WCAP-14483-A

# Generic Methodology for Expanded Core Operating Limits Report

SUBJECT: ACCEPTANCE FOR REFERENCING OF LICENSING TOPICAL REPORT  
WCAP-14483, "GENERIC METHODOLOGY FOR EXPANDED CORE  
OPERATING LIMITS REPORT" (TAC NO. M94338)

SAFETY EVALUATION BY THE OFFICE OF NUCLEAR REACTOR REGULATION  
RELATING TO TOPICAL REPORT WCAP-14483  
GENERIC METHODOLOGY FOR EXPANDED CORE OPERATING LIMITS REPORT

Figure 2.1.1-1 (page 1 of 1)  
Reactor Core Safety Limits

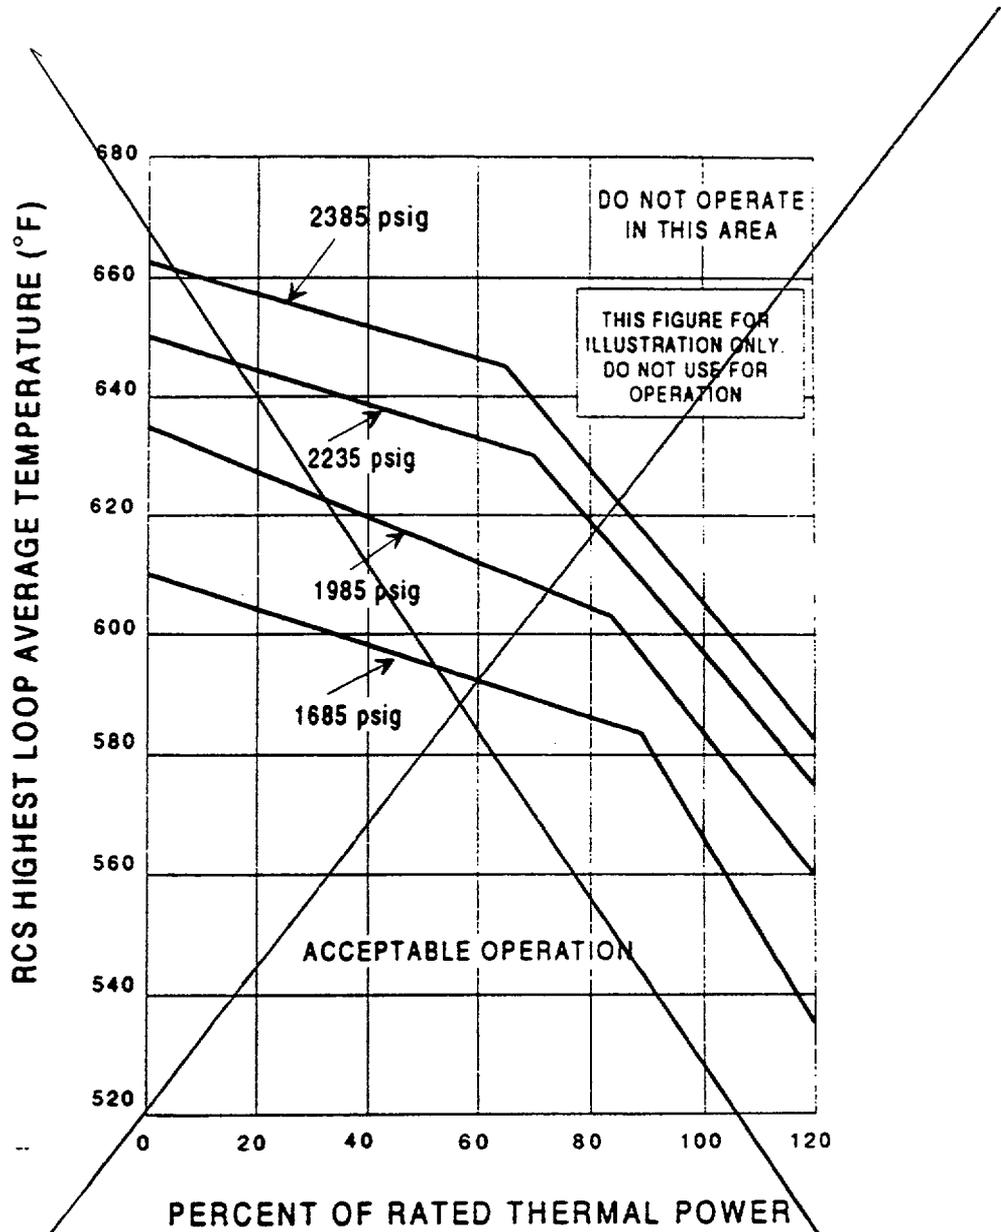
The current TS figure (2.1.1-1) presents core limits on RCS temperature conditions (T-avg) as a function of pressurizer pressure and fractional rated thermal power. This figure was originally included in the Westinghouse TS to satisfy the requirements of 10CFR50.36 which states that "safety limits for nuclear reactors are limits upon important process variables that are found to be necessary to reasonably protect the integrity of certain physical barriers that guard against the uncontrolled release of radioactivity." However, the figure is not a complete representation of reactor core safety limits but is intended to provide the relationship between the process variables that are available to the operator (i.e., T-avg, pressurizer pressure, and thermal power) and the DNB design basis safety limit.

To ensure that the requirements of 10CFR50.36 are met, i.e., limits upon important process variables, the WOG has proposed to retain the requirement for a Reactor Core Limits figure in the Safety Limits TS, but relocate the actual figure to the COLR and replace it with the DNB design basis limit and the fuel centerline melt limit (Ref. 2). Both of these limits are criteria that must be satisfied for normal operation and for AOOs to prevent overheating of the fuel cladding and possible cladding perforation which would result in the release of fission products to the RCS and are, therefore, the true safety limits. The reactor protection system (RPS) and the Reactor Core Limits figure would then be used to determine whether the actual DNB and fuel centerline melt safety limits were violated should an event occur that could potentially challenge them. Appropriate functioning of the RPS and the steam generator safety valves ensures that for variations in the thermal power, RCS pressure, RCS average temperature, RCS flow rate, and  $\Delta I$  (percent power in top half of core minus percent power in bottom half of core), the reactor core safety limits will be satisfied during steady-state operation, normal operational transients, and AOOs. Therefore, in the event of an AOO, verification that the RPS and the main steam system safety valves are functioning as designed will ensure that all safety limits are met. In the event that the RPS is not functioning as designed, an evaluation of any

In addition, since the Reactor Core Limits figure is based on the nuclear enthalpy rise hot channel factor limit,  $F_{\Delta H}^N$ , and the RCS total flow rate, both of which may be in the COLR, relocation of the figure to the COLR would eliminate the need for a license amendment if cycle-dependent changes to these parameters were to exist.

It is recognized that DNB and fuel centerline melt are the true safety limits. However, since these are not measurable quantities, they do not meet the requirements of 10CFR 50.36 which states that technical specification safety limits are limits upon important process variables. Justify how the requirements of 10 CFR 50.36 would still be met if Figure 2.1.1-1 were deleted.

- 1) It is recognized that DNB and fuel centerline melt are the true safety limits. However, since these are not measurable quantities, they do not meet the requirements of 10 CFR 50.36 which states that technical specification safety limits are limits upon important process variables. Justify how the requirements of 10 CFR 50.36 would still be met if Figure 2.1.1-1 were deleted.

The staff concludes that the Reactor Core Limits figure may be relocated to the COLR and replaced with the DNB design basis limit and the fuel centerline melt limit. The NRC-approved methodology used to derive the parameters in the figure is contained in WCAP-9272-P-A, "Westinghouse Reload Safety Evaluation Methodology," dated July 1985, (or other applicable approved reload methodology), and will be referenced in the Reporting Requirements section of the TS.

Technical Specification Figure 2.1.1-1 provides a relationship between the process variables of  $T_{avg}$ , pressurizer pressure, and rated thermal power, and the DNB design basis limit. This Figure is a representation of "reactor core limits" and is not a complete representation of reactor core safety limits. The Figure can change on a cycle specific basis due to changes to  $F_{\Delta H}$  and RCS flow rate. As discussed in WCAP-14483, and stated above, the reactor core safety limits are DNB design basis limit and fuel centerline melt. The Reactor Protection System and the reactor core limits (Figure 2.1.1-1) would be used to determine whether the actual reactor core safety limits (DNB design basis limit and fuel centerline melt) were violated, should an event occur that could potentially challenge them. The Applicable Safety Analyses Section of the Bases of Technical Specification 2.1.1, contained in WCAP-14483, discusses verification of reactor core Safety Limits. This Figure is not used by the operators during plant operation. The relevant DNB process variables used by the operators are addressed by the Technical Specification requirements for RCS pressure, temperature, and flow.

To ensure that the requirements of 10CFR50.36 are met, i.e., limits upon important process variables, it is proposed that the requirement for a Reactor Core Limits Figure (2.1.1-1) be retained in the Technical Specifications, but contained in the Core Operating Limits Report (COLR), consistent with Generic Letter 88-16. The methodology used to calculate the reactor core limits figure is contained in WCAP-9272-P-A, "Westinghouse Reload Safety Evaluation Methodology", July 1985.

Figure B 2.1.1-1 (page 1 of 1)  
Reactor Core Safety Limits vs. Boundary of Protection

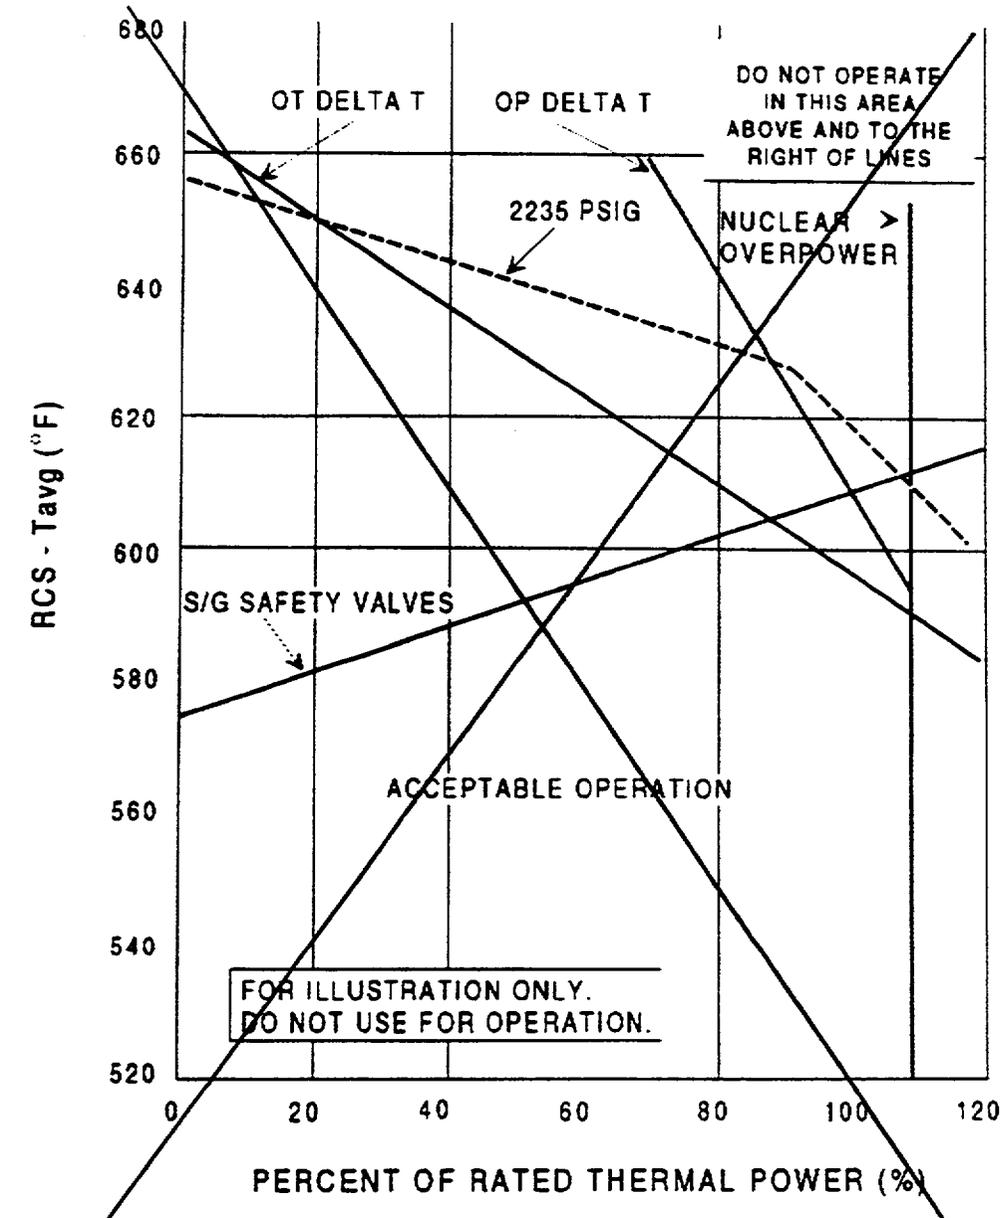
~~The curves provided in Figure B 2.1.1-1 show the loci of points of THERMAL POWER, RCS pressure, and average temperature for which the minimum DNBR is not less than the safety analyses limit, that fuel centerline temperature remains below melting, that the average enthalpy in the hot leg is less than or equal to the enthalpy of saturated liquid, or that the exit quality is within the limits defined by the DNBR correlation.~~

~~The curves are based on enthalpy hot channel factor limits provided in the COLR. The dashed line of Figure B 2.1.1-1 shows an example of a limit curve at 2235 psig. In addition, it illustrates the various RPS functions that are designed to prevent the unit from reaching the limit.~~
